Appeal of Planning Commission Resolution No. 25-02 Regarding Coastal Development Permit No. 22-009 (24515 Vantage Point Terrace, APN 4458-033-005; Owner, 24515 Vantage Point Syndication LLC; Appellant, Alistair Saeghi)

Appeals of Planning Commission Resolution No. 25-03 Regarding Coastal Development Permit No. 20-003 (29329 Heathercliff Road, APN 4468-011-011; Owner, ACS International, LLC; Appellants, Larry Roth and Brian Adams)

Malibu City Council
Special Meeting Agenda

NORTH	DATE	PROJ. #	SCALE	DRAWING
	10/21/24 12:51 PM	19-2018	1/8" = 1'-0"	A-0.1
	DRAWN	CAD BY	FLOOR	
	Author	Designer

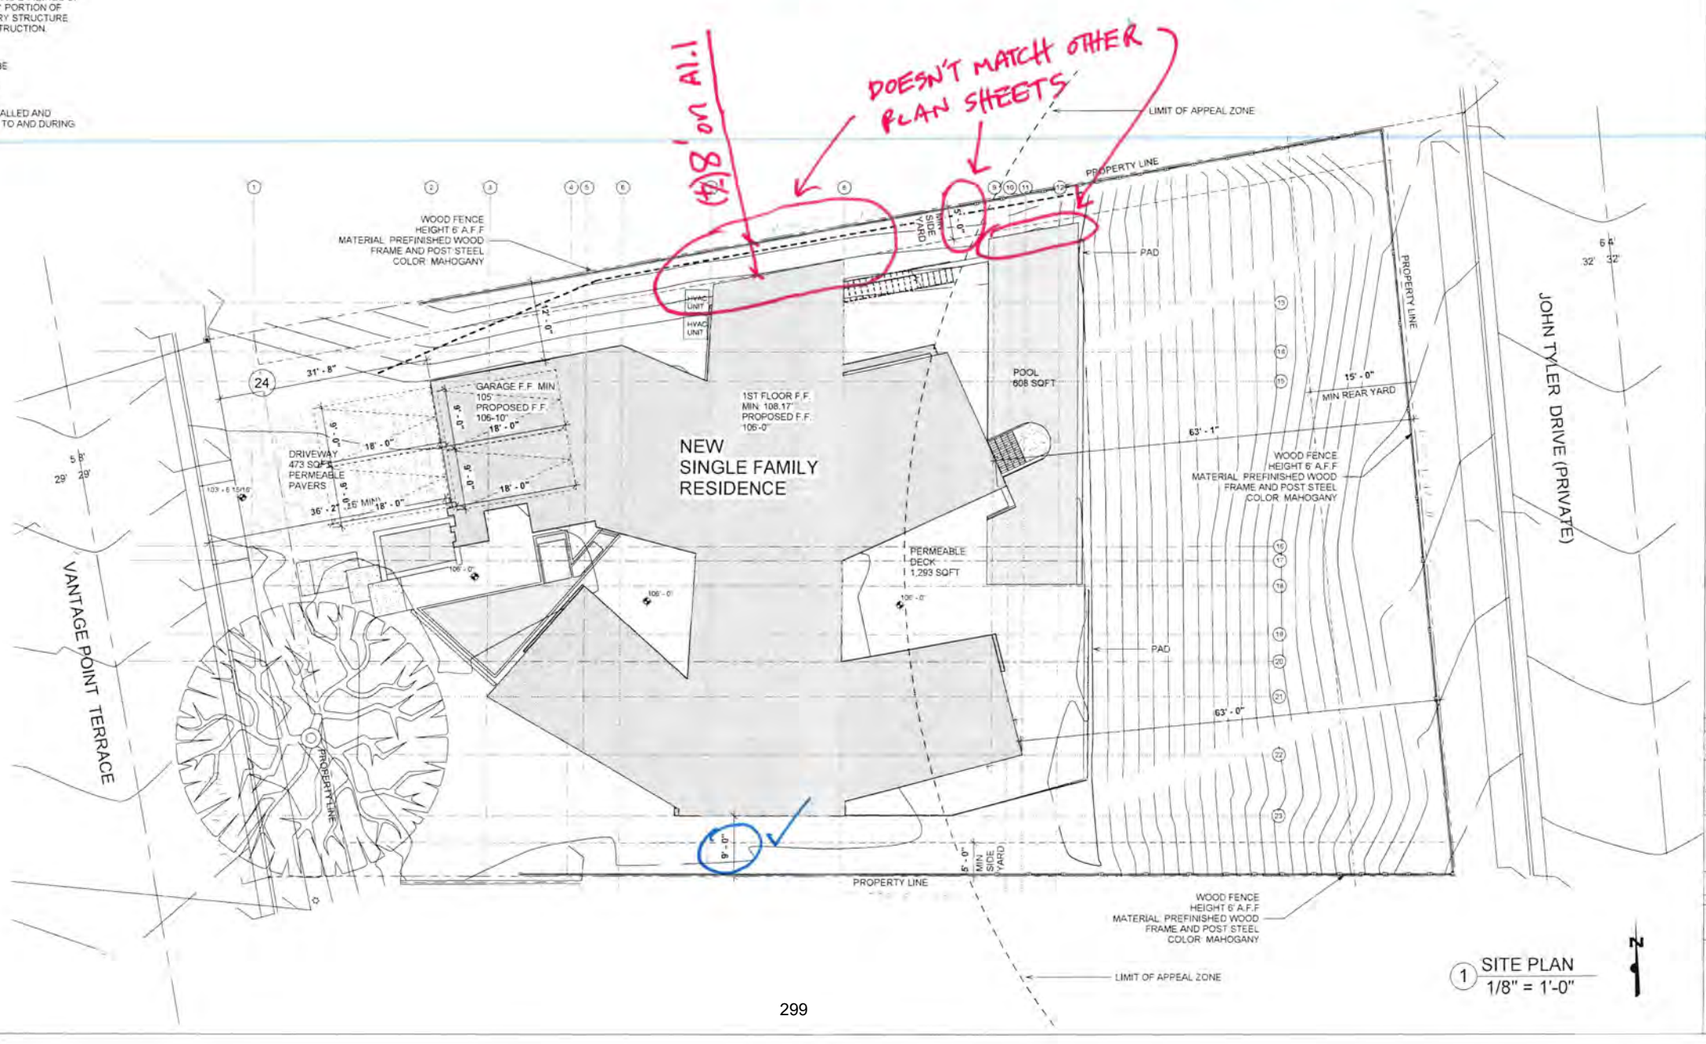
THIS PLAN SHOWS 5' SETBACK TO DINING ROOM & POOL, BUT OTHER SHEETS DEPICT (+/-) 8' SETBACK

NORTH	DATE	PROJ #	SCALE	DRAWING
	09/22/22 3:34:23 PM			
	DRAWN	CKD BY	AS NOTED	A-1.2
	Author	Designer

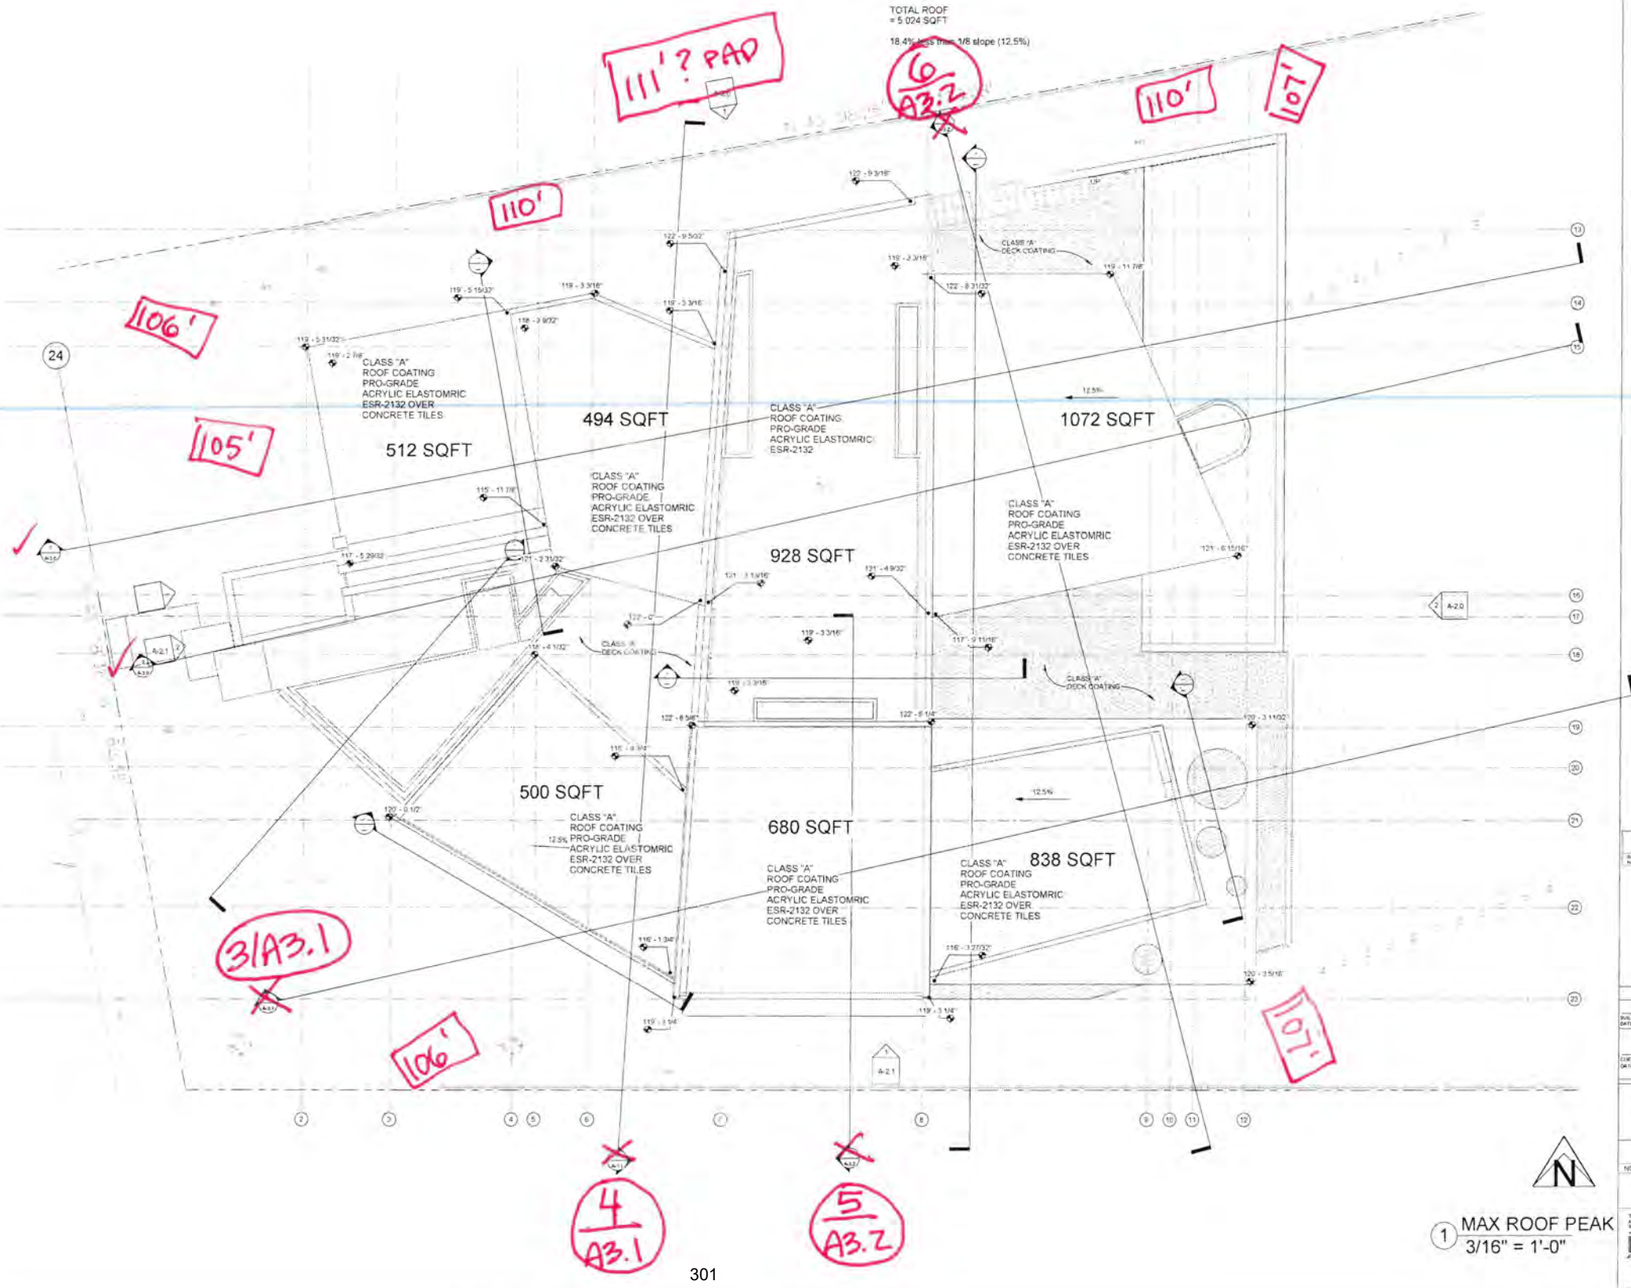
17 VENTS NEEDED

Original Roof Deck

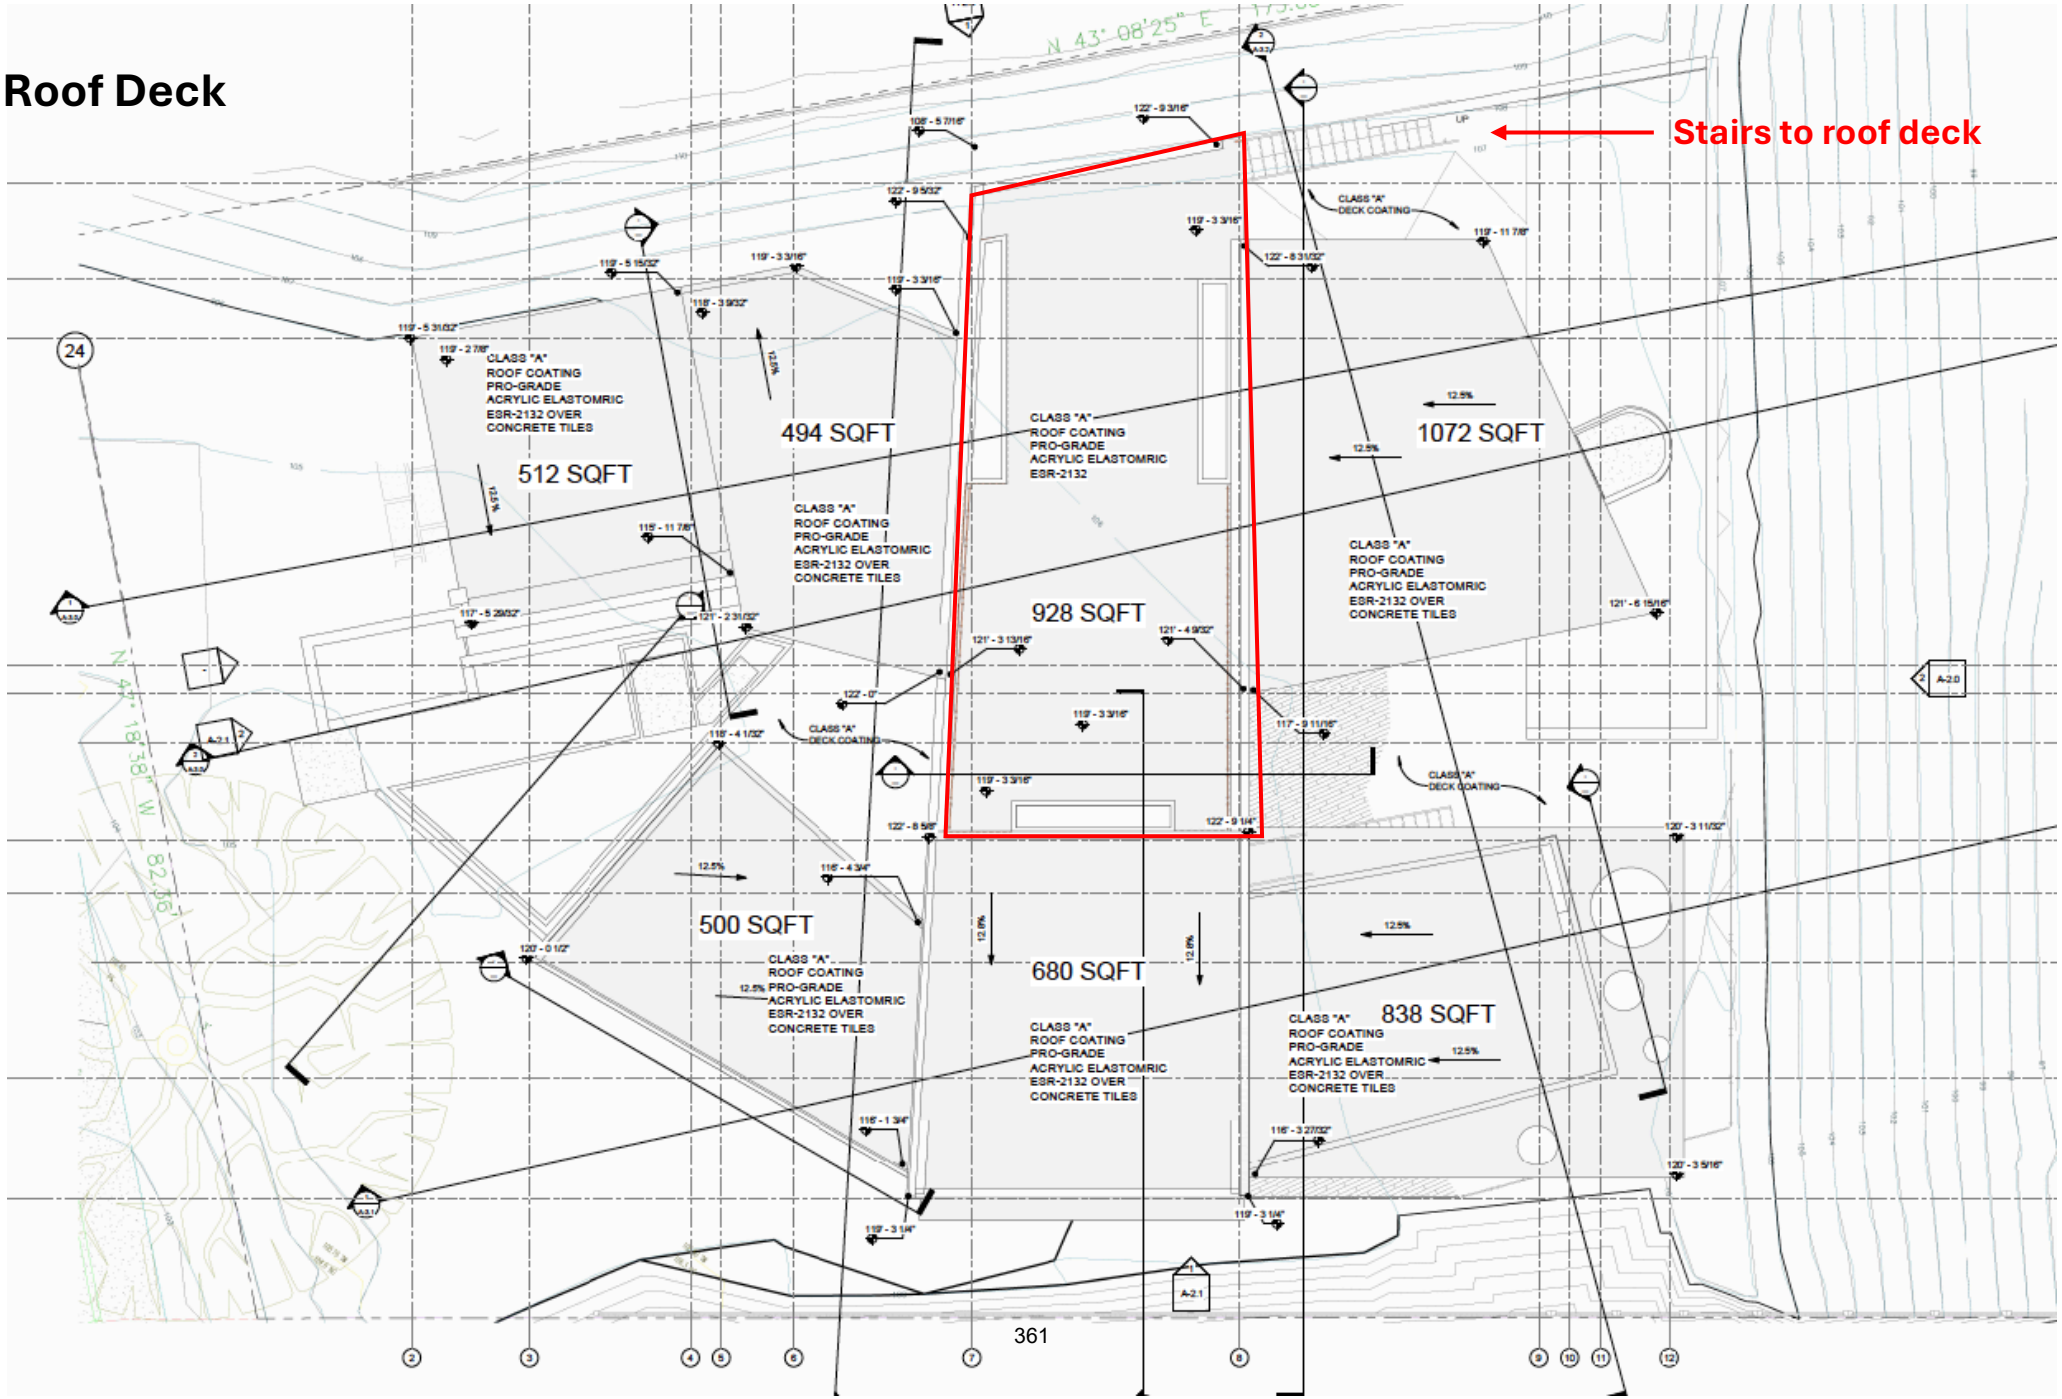
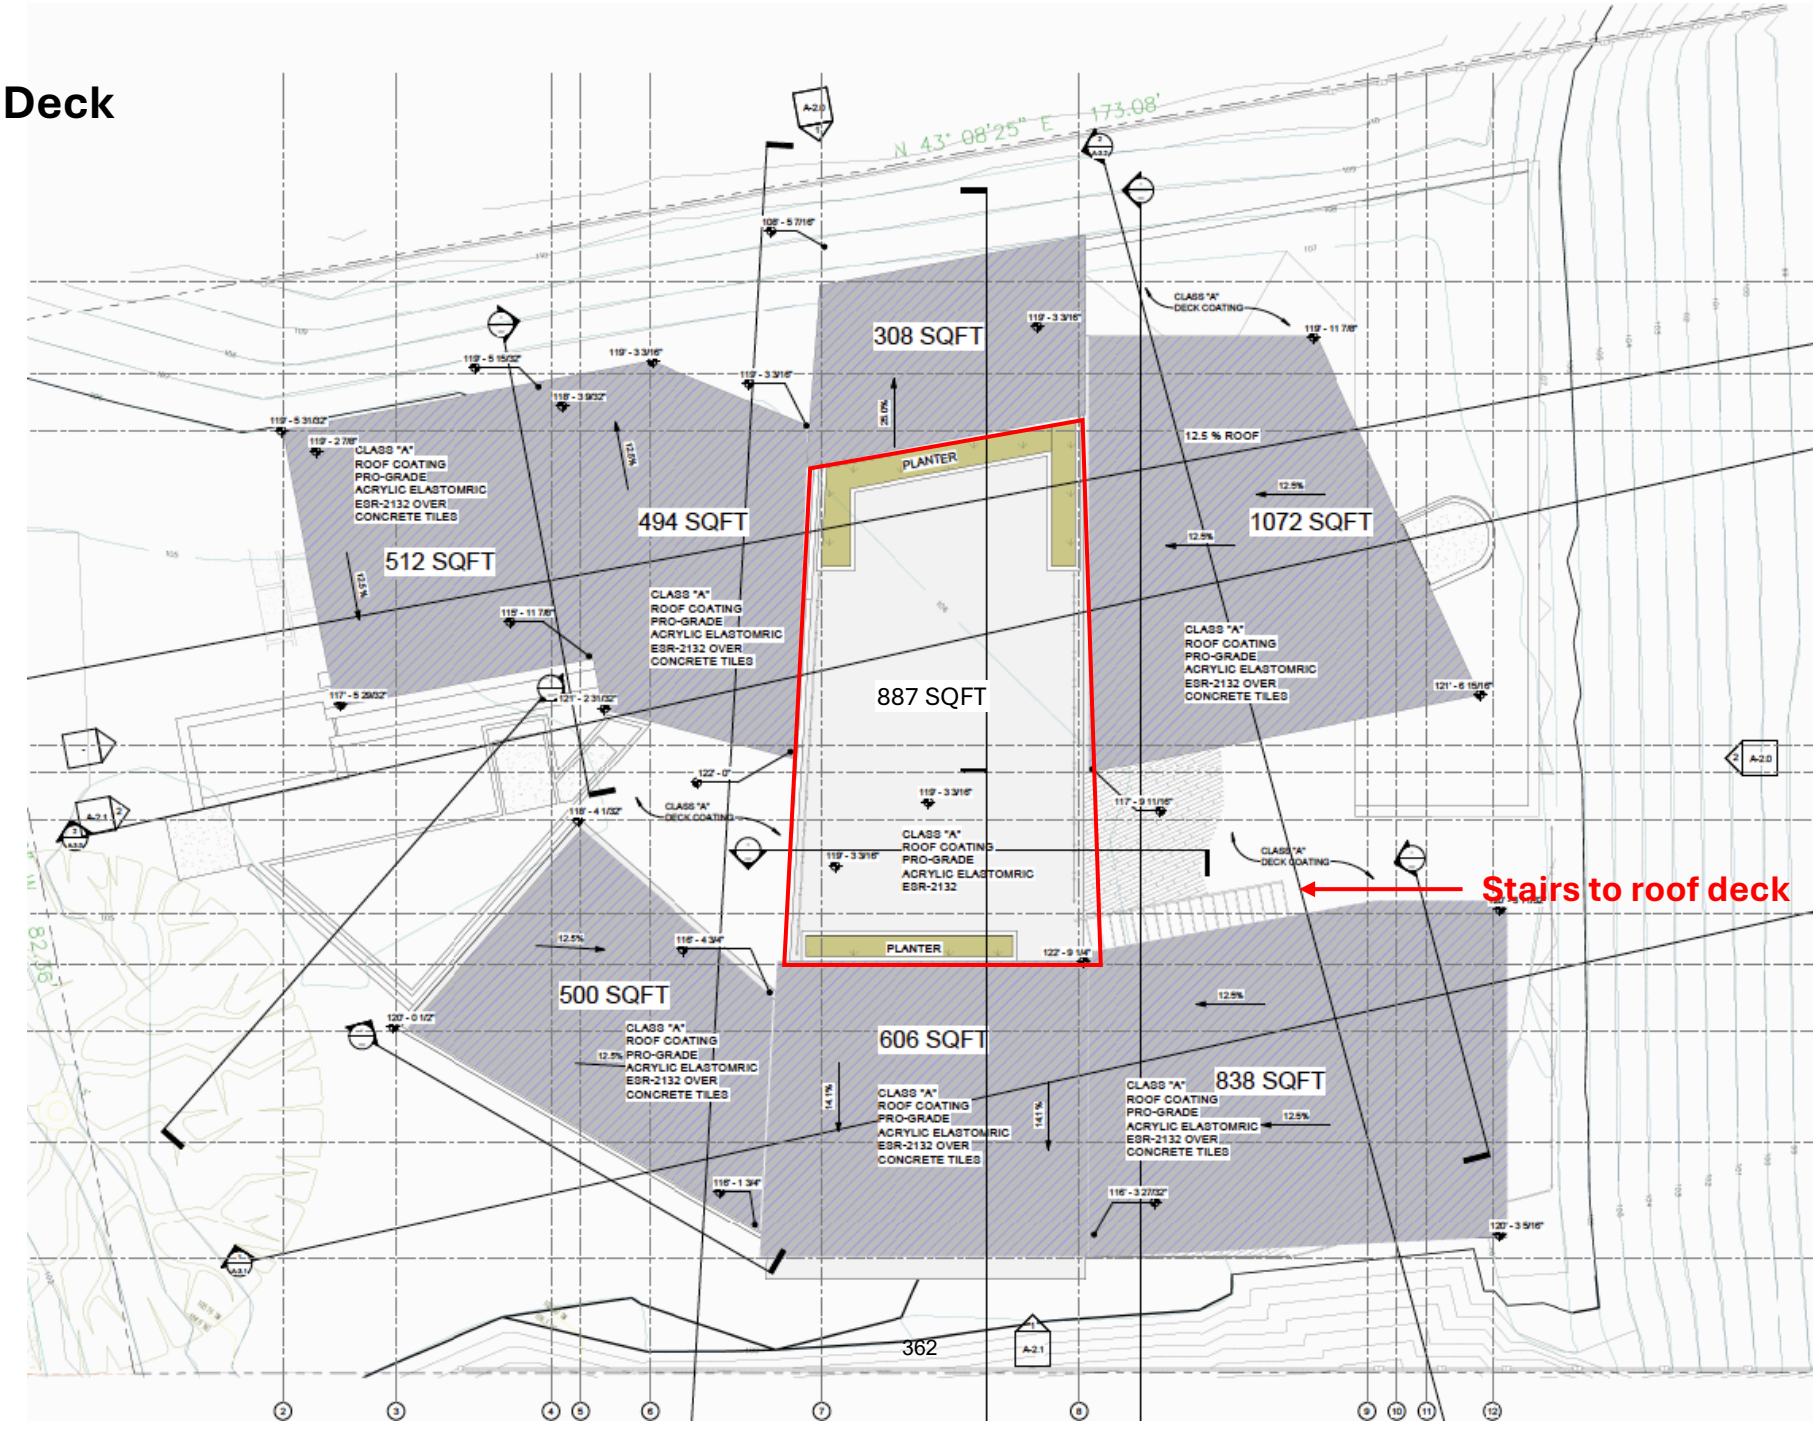
Figure 2 – Original and Revised Roof Deck
